RE: PLUS review – PLUS 2007-08-06; Overbrook Park Center

Thank you for meeting with State agency planners on August 22, 2007 to discuss the proposed plans for the Overbrook Park Center project to be located at the intersection of Coastal Highway and Cave Neck Road.

According to the information received, you are seeking a rezoning through Sussex County for a 30,857 sq. ft. business park consisting of a 13,800 sq. ft. retail building, a 3,562 sq. ft. bank and a 13, 225 sq. ft. drug store.

**Map of Overbrook Park Center** The parcel identified in this project is outlined in blue. The excellent recharge potential area is shown in green.

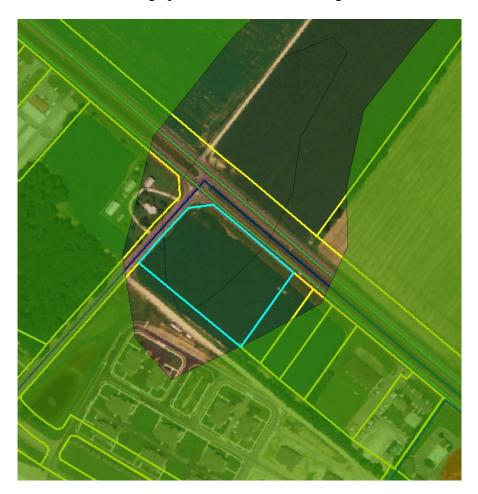
The Water Supply Section, Ground Water Protection Branch, has determined that it does not fall within any delineated wellhead protection area or an area of excellent groundwater recharge potential. The proposed project is surrounded by excellent recharge potential area (see following map).
